Central Coast  
Local Planning Panel Meeting  
Business Paper  
**12 October 2023**

**Item No:** 3.1  
**Title:** DA/146/2022 - 275 Ocean View Parade, ETTALONG BEACH - Commercial/residential development  
**Department:** Environment and Planning

Reference: DA/146/2022 - D15855686  
Author: Sian Holmes, Development Planner Consultant  
Manager: Ailsa Prendergast, Acting Unit Manager, Development Assessment  
Executive: Andrew Roach, Director Environment and Planning (Acting)

Figure 21 – LEP Building height diagram (CD Architects, 20.3.2023)

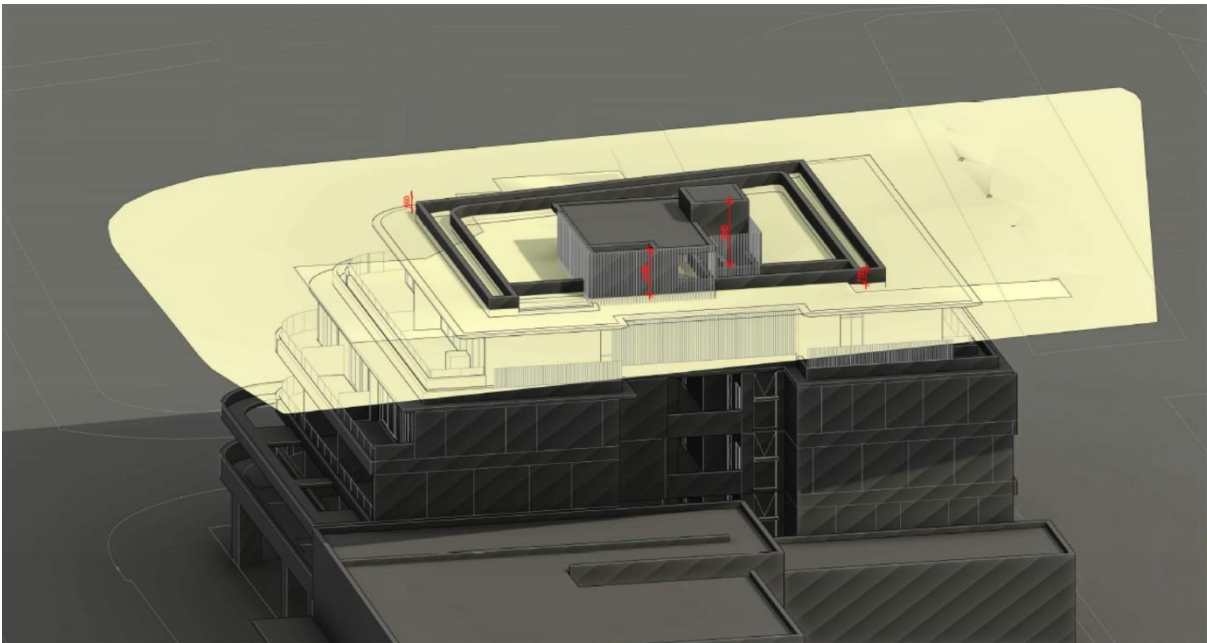
The proposed development has a maximum height of 20.31 as outlined above. The proposal results in a 3.31m non-compliance with the maximum height of building development standard (17m). The departure encompasses the stairs to the roof level and enclosed area (+2.28m), lift core (+3.31m) and part of the roof level parapet wall (+660mm to 755mm) (Figure 21).

The above arguments (and the remainder of the clause 4.6 variation request) do not justify the height non-compliance. The site's location in the local centre and main street of the Ettalong Village is clearly acknowledged through the applicable planning controls which allow for a more intensive form of development than on surrounding land. A building of 17m in height would clearly be a significant element in the Ettalong Village streetscape and whilst it is acknowledged that a floor level of RL5.01 is required due to flood constraints, this floor level does not result in a building that exceeds the maximum height limit by 3.3m at its highest point. Further it is noted that the proposal provides for floor-to-floor heights which are generous (Ground – 3.6m, Levels 1 – 3 - 3.1m and Level 4 – 3.2m) and which could readily be reduced to improve compliance.

It is argued that the height non-compliance is minor and would not be visible from the street however no information has been provided to demonstrate this. The site is highly visible being located on a significant corner at the entrance to the village and considered likely that the area of non-compliance will be visible from surrounding streets and will add to the overall bulk and scale of the buildings.

Figure 23: Non-compliance with DCP building envelope control on Memorial Avenue

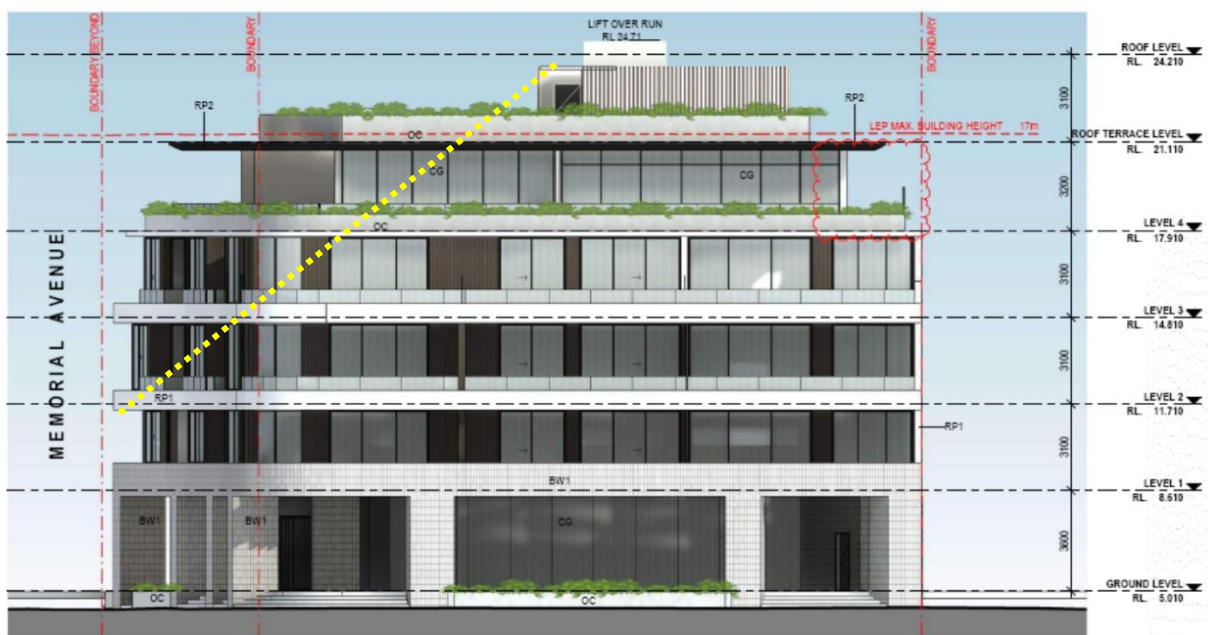
The extent of the proposed height exceedance can be seen in Figure 24 above. While the elements which exceed the height limit are centrally located within the building the

exceedance is significant and will add to the perceived height and bulk of the building. This is particularly significant given the site location at the entry to the Ettalong Beach local centre. In respect of the Memorial Avenue frontage the proposal does not comply with the GDCP 2013 building envelope controls which call for a two-storey street wall height with buildings setback on a 45 degree angle above as illustrated in Figure xx below. The building presents a four-storey street wall to frontage which will result in a significantly bulkier building than is provided for under the controls. Being located on a prominent corner this will be highly visible and will dominate the frontage.

Further the non-compliance results in additional shadowing of the public domain between the protected period of 10am and 2pm in midwinter (GDCP 2013 section 4.2.5.2 Building Setbacks and Envelopes). This matter is discussed in further detail below.
